Groundwater Application Review Summary Form

Application # G- 19258

GW Reviewer Stacey Garrison/Travis Brown Date Review Completed: 6/12/2023

PUBLIC INTEREST REVIEW FOR GROUNDWATER APPLICATIONS

Water-Level Measurements in Nearby Wells

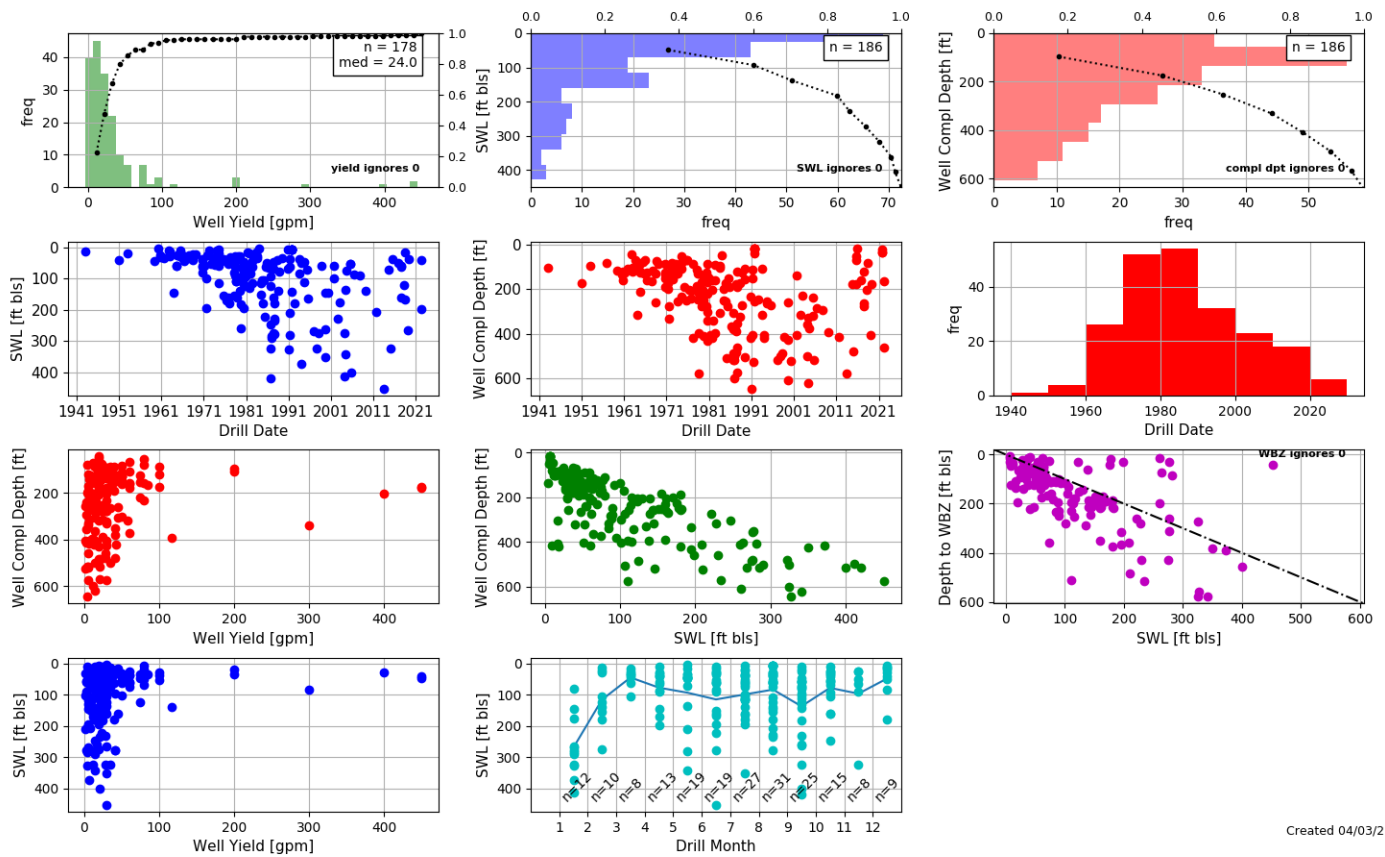
- Department SWL data is limited in this area (1 to 5 miles from POAs) to five wells that utilize the same portion of the TMVS aquifer targeted by the POAs; this limited data indicate water level trends are declining (see Water Level Measurements in

Nearby Wells). Four of the wells (CLAC 60456, MARI 9318, MARI 51915, MARI 58081) have declined approximately 10 ft (7 to 12 ft) in the last 10 years, and MARI 57858 has declined approximately 40 ft in 8 years. The deeper fractured WBZs of the TMVS aquifer are likely more susceptible to over-drafting due to the mineralization deposits in the fractures, reduced recharge, and the discontinuity of fracture flow paths (Conlon et al 2005, Piper 1942). **The proposed use will not likely be available within the capacity of the groundwater resource.** Data provided with the application and during this review indicate that **water levels in the well nearest the proposed POAs and completed to a similar depth as the proposed POAs (CLAC 15256) have declined excessively** (see CLAC 15256 well log, CLAC 15256 well test report, and CLAC 15256 email, attached). The SWL recorded on the well log for CLAC 15256 is the highest known water level, and recent SWL measurements taken in December 2020 and March 2023 show declines that exceed 50 ft, meeting the criteria of declined excessively in OAR 690-008-0001 (4) (d). The CLAC 15256 well log SWL is plausible based on the comparable SWL for a nearby well completed to a similar depth as CLAC 15256 and the proposed POAs (CLAC 15245). **There is a preponderance of evidence to support that the water levels in the groundwater reservoir are declined excessively; therefore, the groundwater reservoir is over-appropriated.**

Well Statistics 6S/1E-15 and surrounding sections

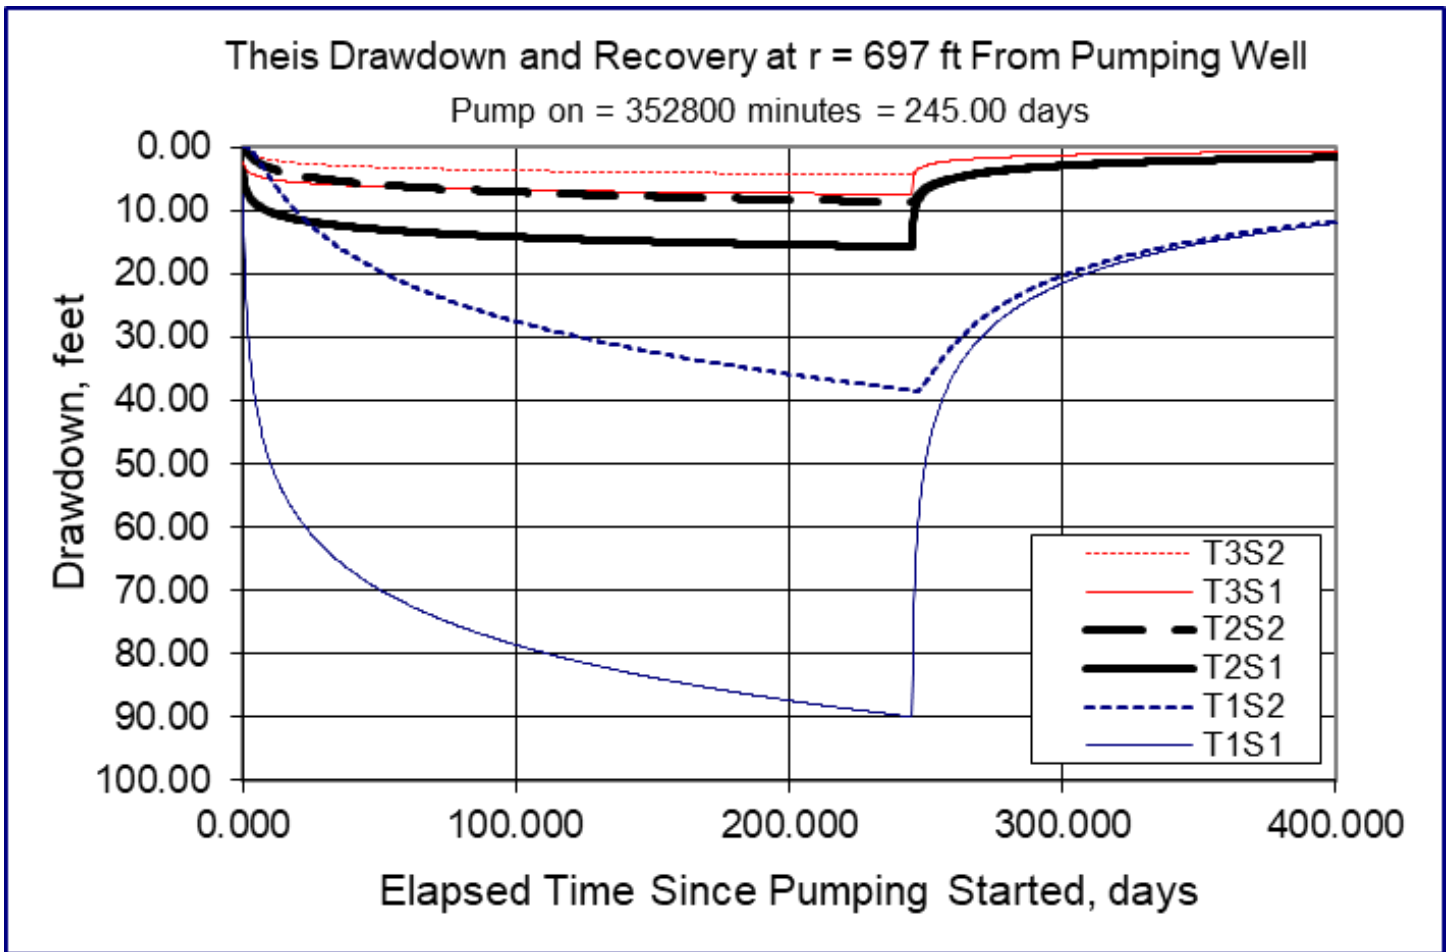
- A review of statistics for nearby well records was completed and compared with the proposed rate of 0.0978 cfs (43.9 gpm) for this application (see Well Statistics). The proposed rate of use of 0.0978 cfs (43.9 gpm) is likely within the capacity of the groundwater resource; median reported well yield is 24 gpm, and the maximum reported yield is 450 gpm. The proposed rate for this application is 183% of the median and 10% of the maximum reported yield. Lithology and aquifer identification are not available for all wells in the Department's database, and the higher yields in the query may be utilizing Columbia River Basalt or alluvial sediments of the Willamette Aquifer and not be representative of the Scotts Mills Formation. For the 9 productive wells included in the geology analysis above the maximum yield is 100 gpm, the minimum is 5 gpm, and the median is 29 gpm.

Well 1

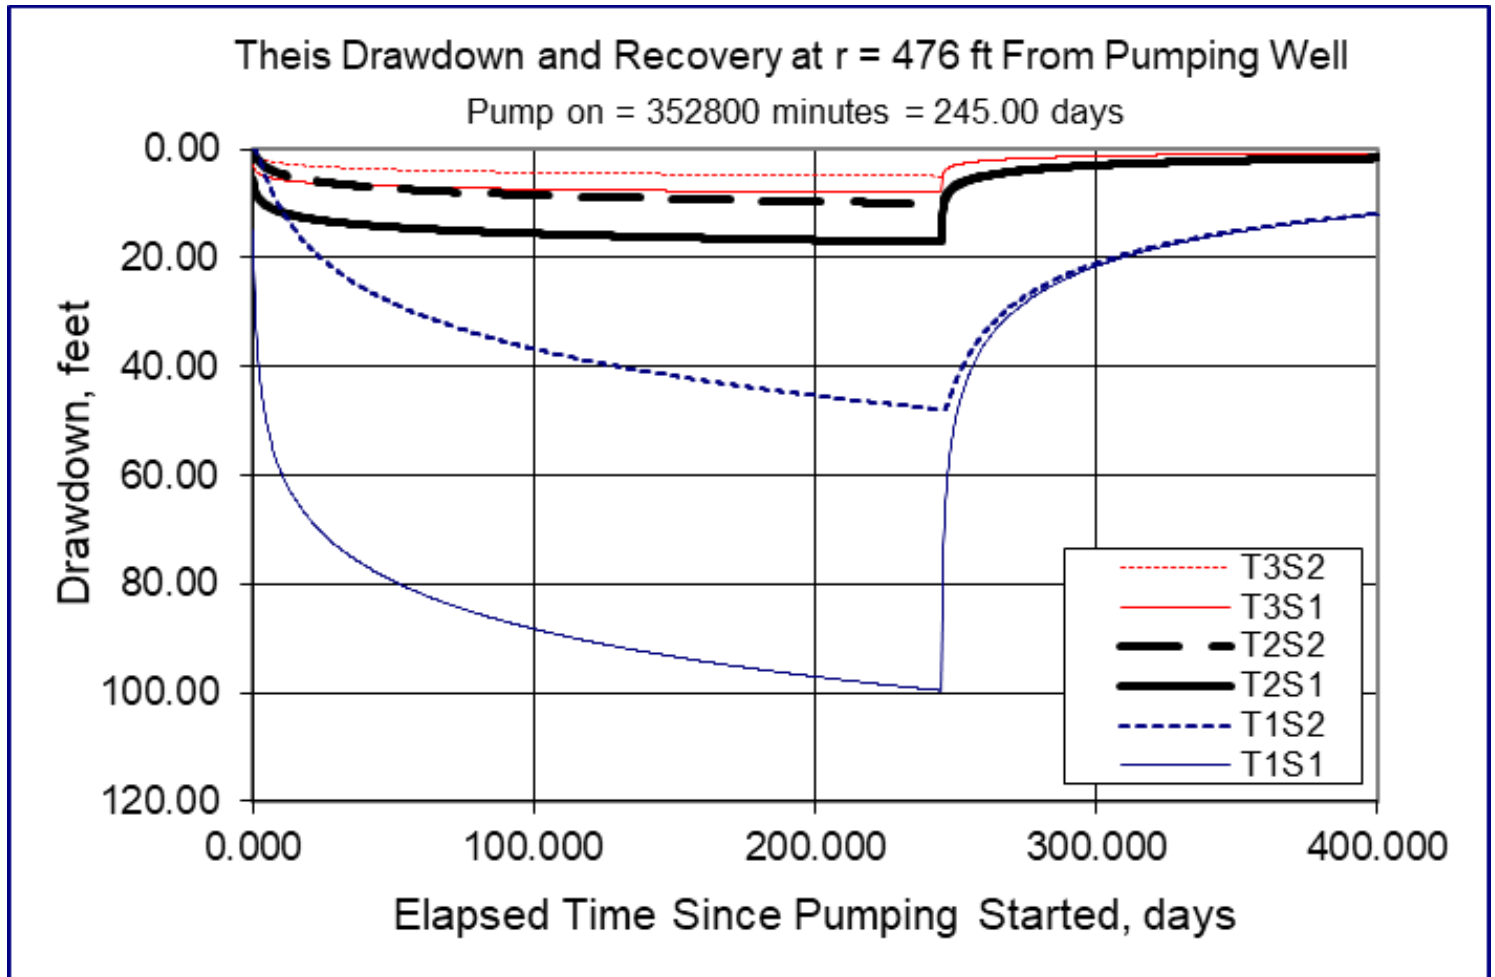
The nearest groundwater user to Well 1 is CLAC 15260 (an exempt domestic well) 697 ft northwest of the POA at an elevation of ~466 ft msl. CLAC 15260 is drilled to 119 ft bls [347 ft msl] with a WBZ from 62 to 63 ft bls [380 to 381 ft msl], and a seal depth of 22 ft bls [421 ft msl]. It is likely the proposed use would cause some degree of well-to-well interference with CLAC 10257. To assess the degree of drawdown, a Theis drawdown analysis was conducted for the proposed use (see attached **Theis Drawdown Analysis-Well 1**). Results indicate that the proposed use is not likely to cause well-to-well interference with CLAC 15260 that exceeds the threshold under the standard condition for TMVS aquifers in the Willamette Basin.

Radial distance from pumping well (r)=697 ft [estimated radial distance to nearest user, CLAC 15260]

Pumping Rate (Q)= 0.0978 cfs (~43.9 gpm)

Aquifer Transmissivity (T1)= 396 gpd/ft (53 ft²/day), (T2)= 2,898 gpd/ft (387 ft²/day), (T3)= 6,687 gpd/ft (894 ft²/day)

Storativity (s1) = 0.00005, (s2) = 0.003 [Conlon et al 2005, Table 2 values for Basement Confining Unit]

Total pumping time=245 days [irrigation season, March 1-October 31]

Well 2

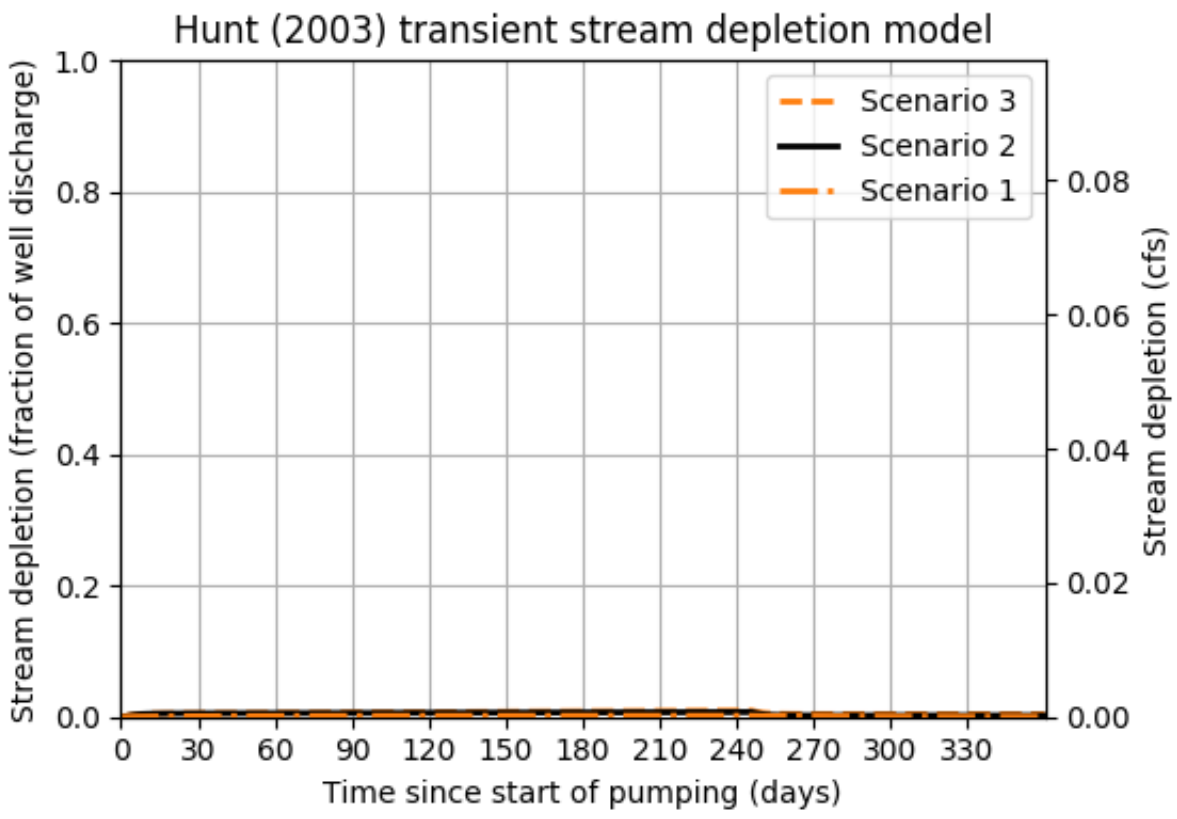
The nearest groundwater user to Well 2 is property at 9905 S Cemetery Rd Molalla OR and is likely MARI 55695 (an exempt domestic well), 476 ft northwest of the POA at an elevation of ~475 ft msl. The well log for MARI 55695 does not record GPS coordinates and the address listed for the well location is not a physical situs address; however, the taxlot number and the TRS Q-Q match this taxlot. A small structure resembling a well house visible via aerial imagery was identified as the most likely well location. MARI 55695 is drilled to 520 ft bls [-45 ft msl] with a WBZ from 318 to 520 ft bls [-45 to 157 ft msl], and a seal depth of 10 ft bls [465 ft msl]. It is likely the proposed use would cause some degree of well-to-well interference with MARI 55695. To assess the degree of drawdown, a Theis drawdown analysis was conducted for the proposed use (see attached **Theis Drawdown Analysis-Well 2**). Results indicate that the proposed use is not likely to cause well-to-well interference with CLAC 57932 that exceeds the threshold under the standard condition for TMVS aquifers in the Willamette Basin.

Radial distance from pumping well (r)=476 ft [estimated radial distance to nearest user, MARI 55695]

Pumping Rate (Q)= 0.0978 cfs (~43.9 gpm)

Aquifer Transmissivity (T1)= 396 gpd/ft (53 ft²/day), (T2)= 2,898 gpd/ft (387 ft²/day), (T3)= 6,687 gpd/ft (894 ft²/day)

Storativity (s_1) = 0.00005, (s_2) = 0.003 [Conlon et al 2005, Table 2 values for Basement Confining Unit]

Total pumping time=245 days [irrigation season, March 1-October 31]
